Subject: Model AP-300 Type A Package
Docket No. 71-9192

Attached are revisions to the SAR for our AP-300 shipping container which has been submitted to you with our application for a Certificate of Compliance. The revisions have been made to satisfy some questions which were posed by your Mr. Richard Odegarden in my telephone conversation with him about two weeks ago.

The responses are related to the structural aspects of the report and have been marked as revision 6 in the text for easy identification. We have expanded the text further to show in detail that the structure of the shipping container is adequate, with a margin of safety, to satisfy the required simultaneous "g" loadings at the center of gravity of the cask during transport.

REVISION 6 - 8/7/85

FIGURE 2.6-1 TOROIDAL RING ENERGY ABSORBER

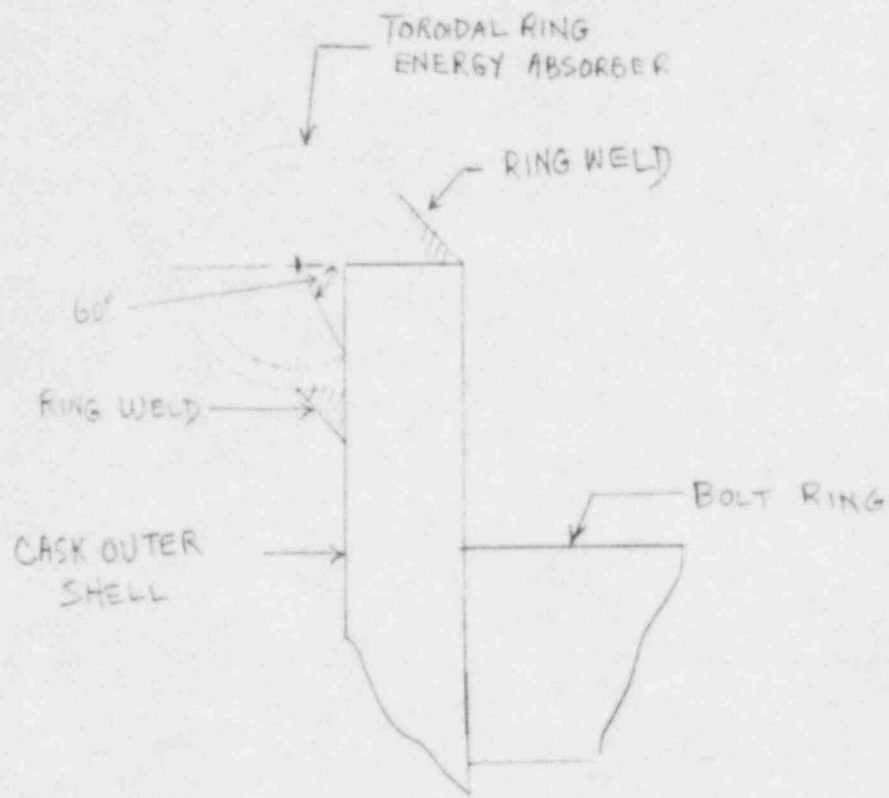
In designing a cask for transport of radioactive material, the regulations require that a free drop of the cask through a predetermined distance (in feet) onto a flat, essentially unyielding surface must be investigated. A segmented toroidal ring will be attached to the ANEFCO AP-300 cask to absorb the energy which is generated by a 1 foot drop of the cask, as shown in Figure 2.6-1. As shown in ORNL-NSIC-68 in Section 2.8.2, this ring will protect the cask closure not only in an end drop, but will operate properly regardless of the angle at which the cask impacts on a horizontal surface. The damage evaluated here is that due to deformation at the impact plane and indirect damage due to deceleration.

The toroidal ring will be a 3" O.D. x $\frac{1}{4}$ " thick steel tube made from 1020 steel hot rolled and electric resistance welded. Using equation 2.17 on page 67 in ORNL-NSIC-68, the energy absorbing characteristics in a crushing impact are correlated by:

The tube will be welded to the cask outside shell with two $\frac{1}{2}$ " fillet welds using E70 ksi low hydrogen electrode, which has an allowable tensile stress of 21 ksi, as shown in Figure 2.6-1.

Figure 2.6-2a AP-300 Cask
Bottom Design

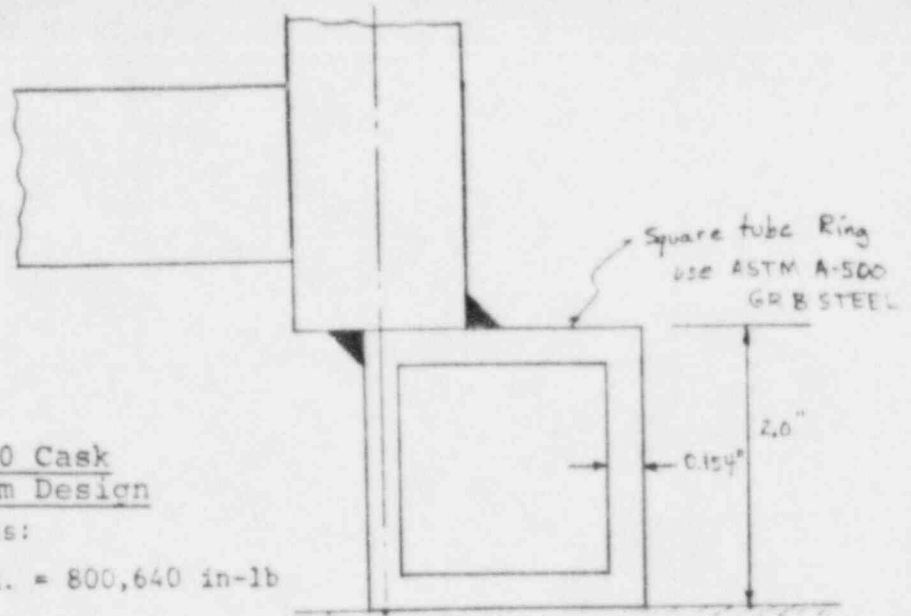
A square tube ring, fabricated from ASTM A500-GRB steel, 2 inches on a side and 0.154" thick, will be installed on the bottom of the cask to absorb the energy during a bottom drop of the AP-300 cask through a height of 12". This arrangement is shown in Fig. 2.6-2a.

133-1 REV. 5

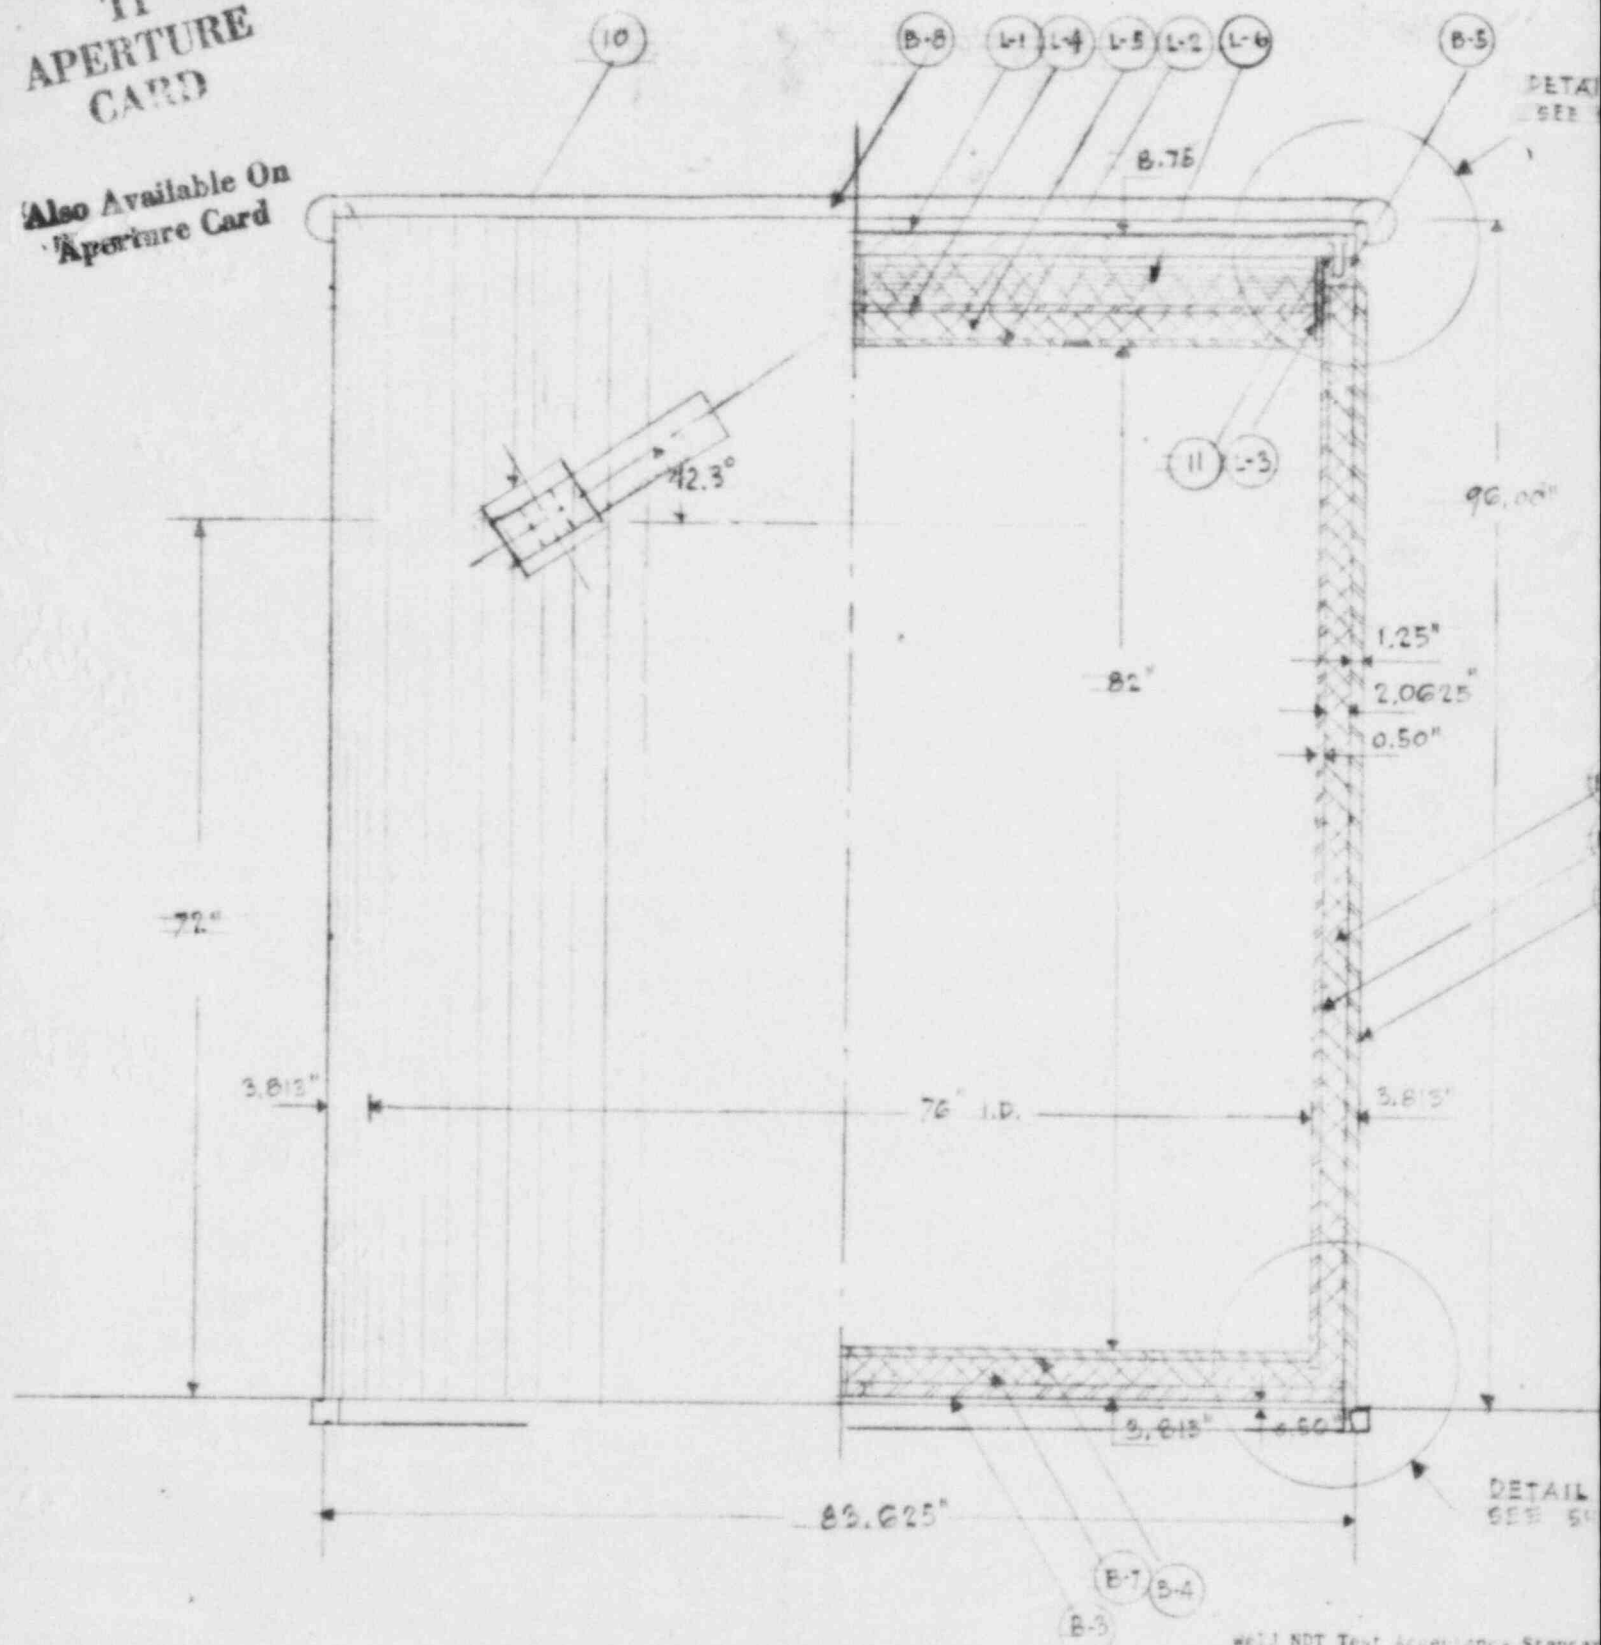
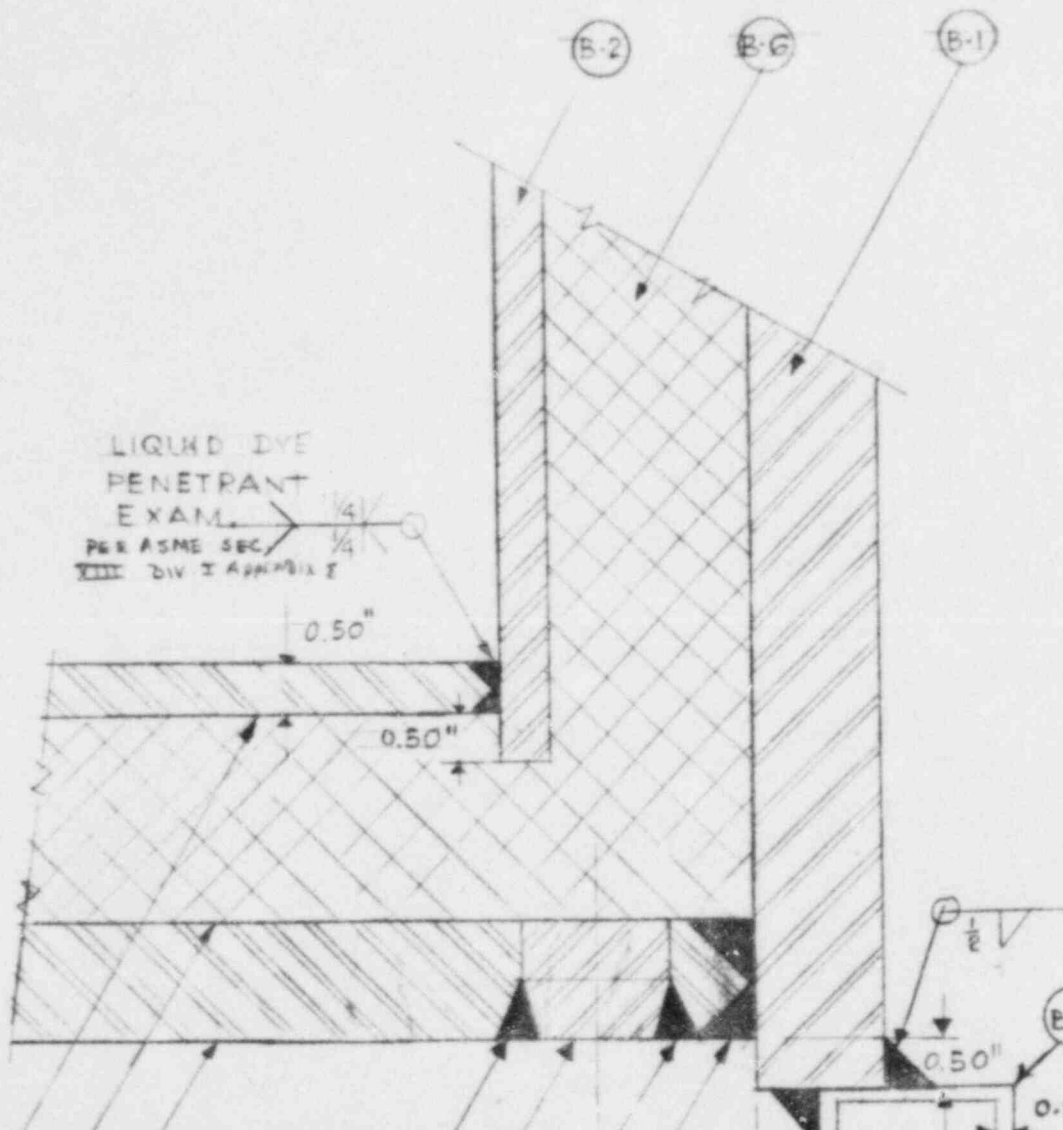
Nº	REVISIONS	APPR.	DATE
1	NOT REQ - ADD REV. BOX	13	1/5/83
2	LID GASKET SPEC. - TIE DOWN PAD	13	2/15/85
3	ADD CONCRETE IN LID VOID	13	3/20/85
4	No. 6-B - REVISE - SUBSTITUTE TOROIDAL RING FOR LIFT PAD; DELETE 6-A - LID LIFTING PAD, CHANGE 6-D TO LIFT/TIE DOWN PAD	13	5/1/85
5	No. 6-B Rev. 4 To 3", ADD - SQUARE RING	13	8/5/85

DRAWING NUMBER
134-1 REV.5

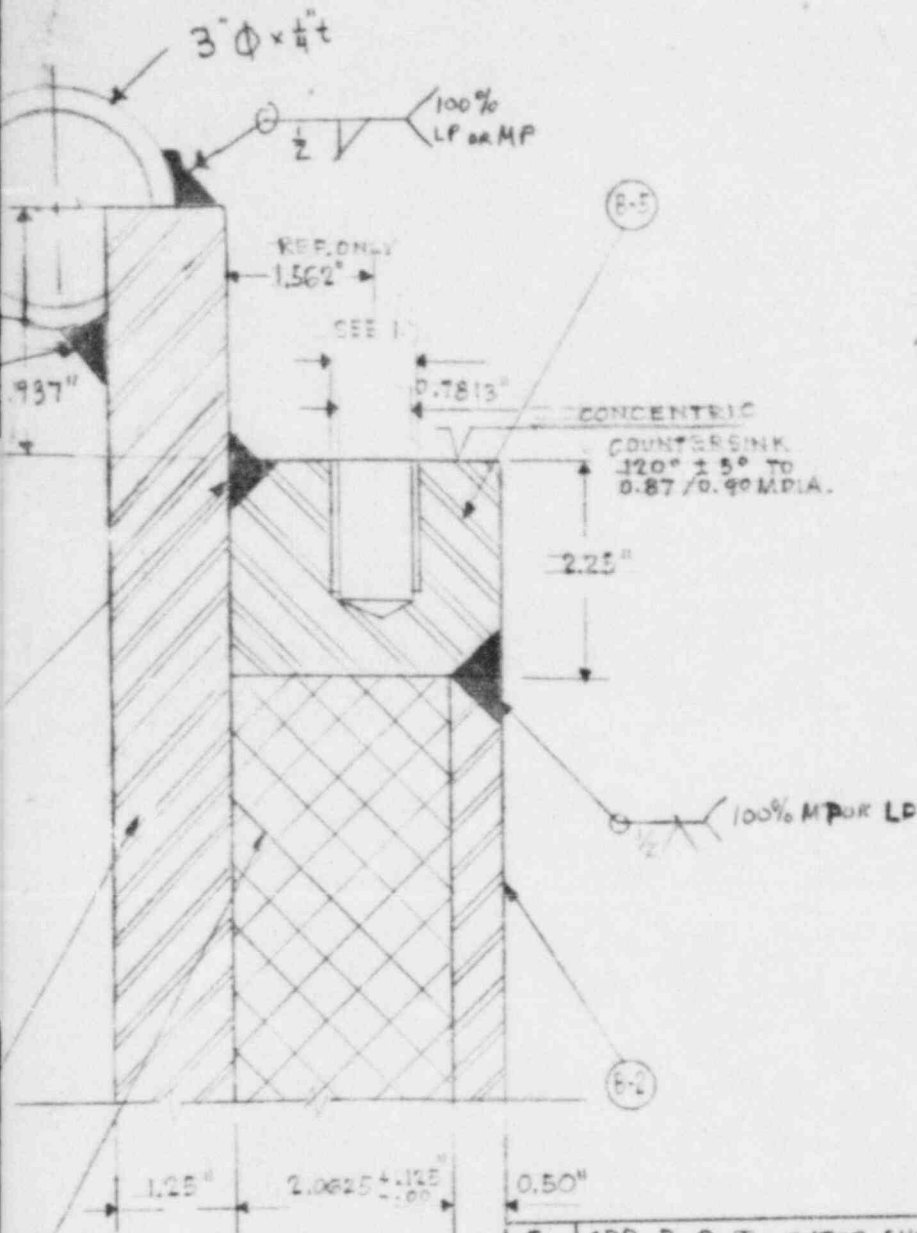
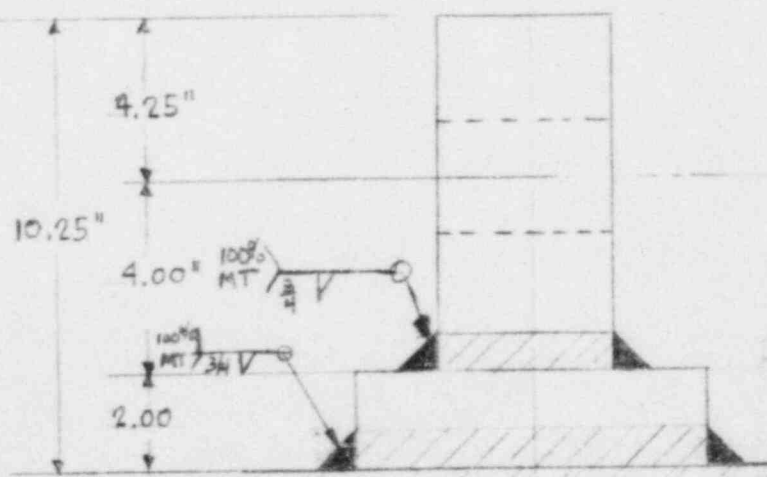
5	ADD B-9 TO OUTER SHELL	13	8/5/85
4	ADD B-B TO OUTER SHELL	13	5/25/85
3	CORRECT WELD SYMBOLS	13	2/1/85
2	WELD NOT REQ	13	11/1/84
1	REVISED WELD SYMBOLS - ADD REV. BLOCK	13	7/15/84
NO	REVISIONS		APPR. DATE
